Culvert Replacement, Bridge and Riparian Construction
Sandpiper East Apartments, Kelsey Creek, Bellevue WA

Addendum No 1.
12-20-2024

DRAWN: MRV	PROJECT NO.: 2200204
DESIGN: BSP	SCALE:
CHECKED: JGM	DATE: 11-2024
DRAWING NO. SDD02	
SHEET NO. 10	OF 40

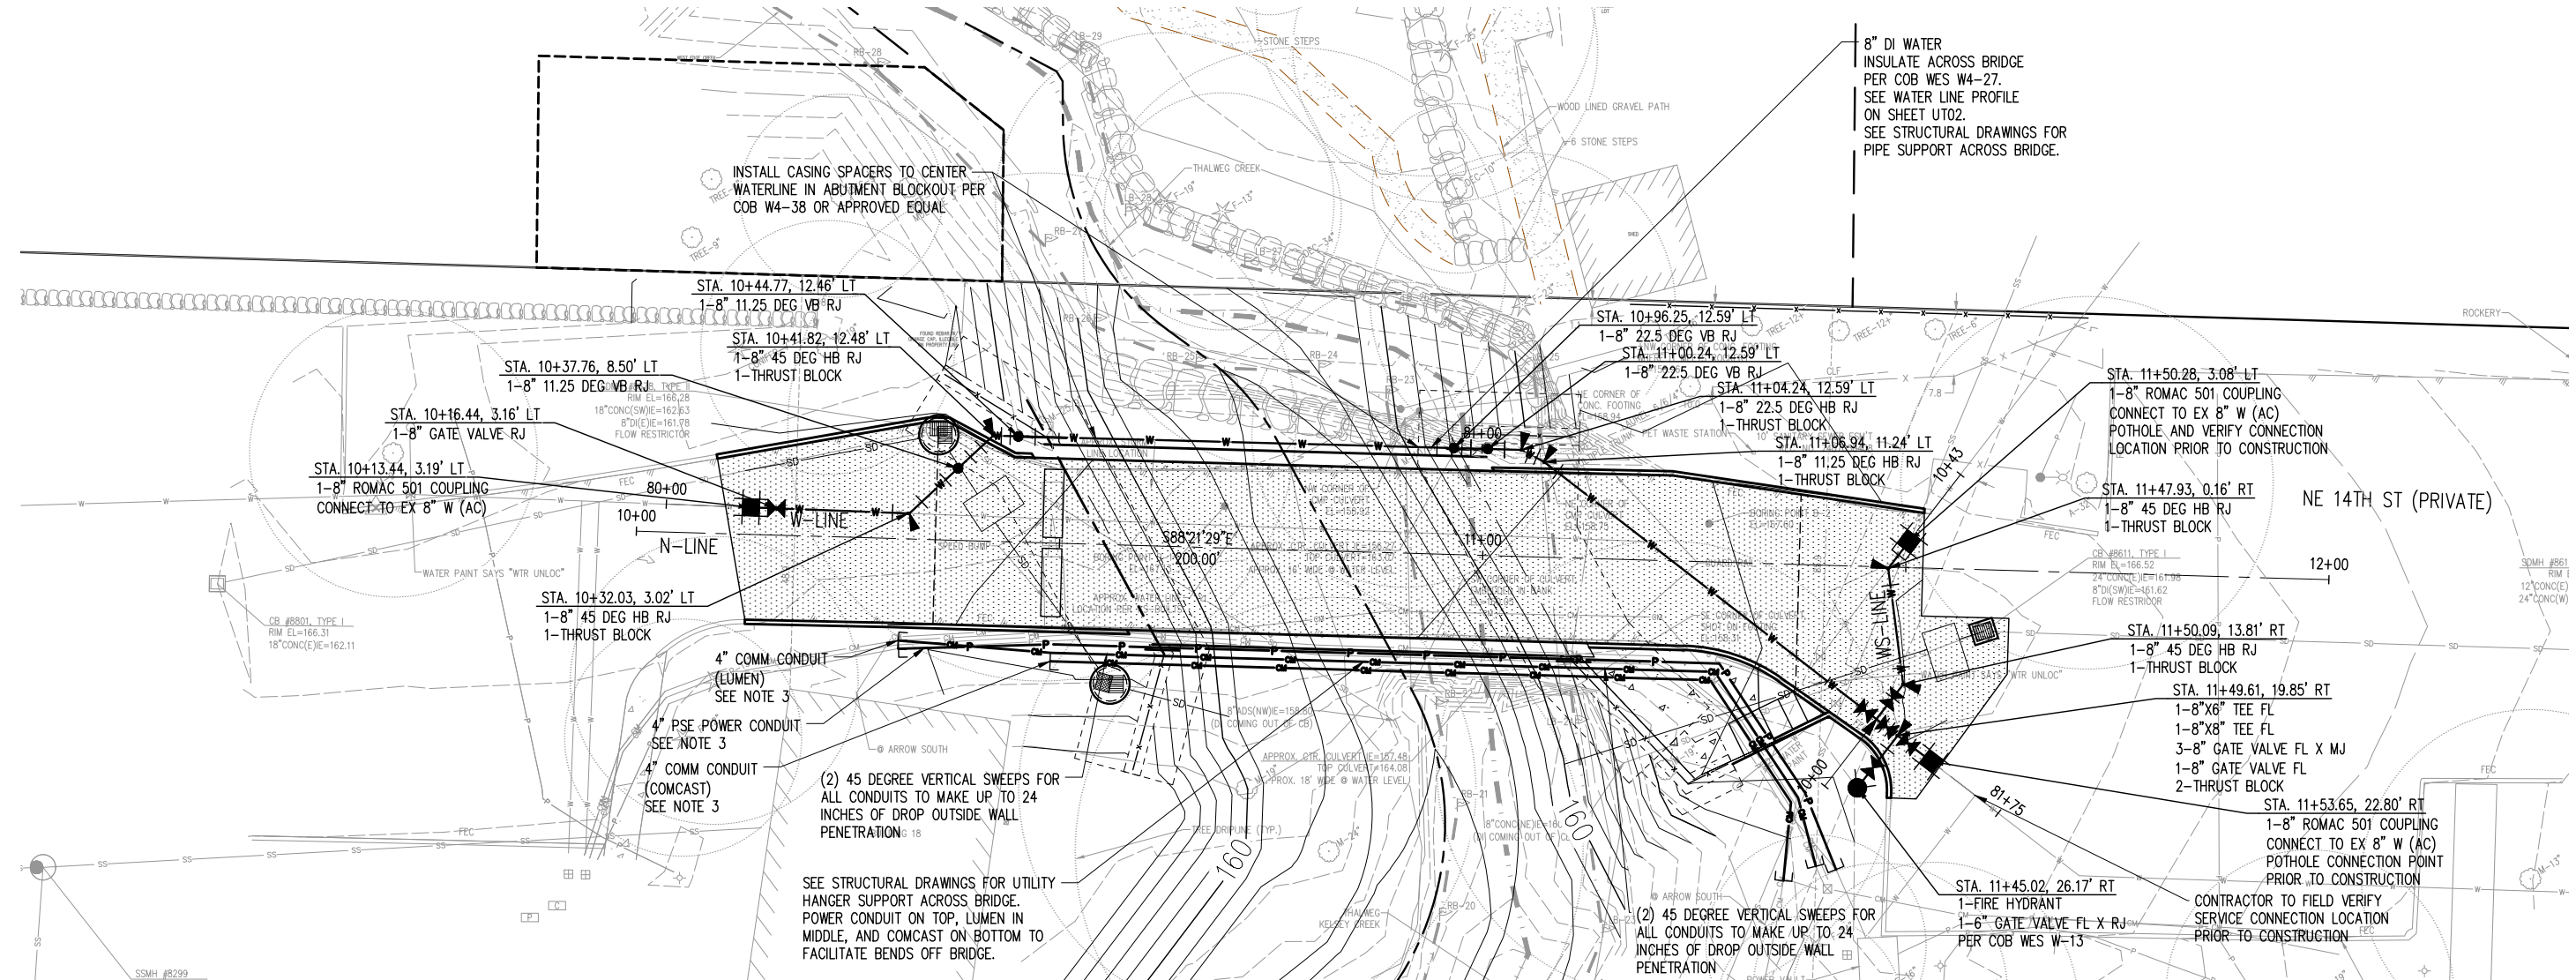
- The lower right corner plan sheet title of page 10 of 40, Sheet SDD02, is revised to be "Water Quality Unit Detail" to match the Index.
- The lower right corner plan sheet title of page 24 of 40, Sheet S11, is revised to be "Girder Details 1" to match the Index.
- A note is added to Sheet UT01, sheet 12 of 40, directing the contractor to notify affected property owners of the water shutdown 2 weeks in advance.

**NE 14TH ST BRIDGE
WATER QUALITY UNIT DETAIL**
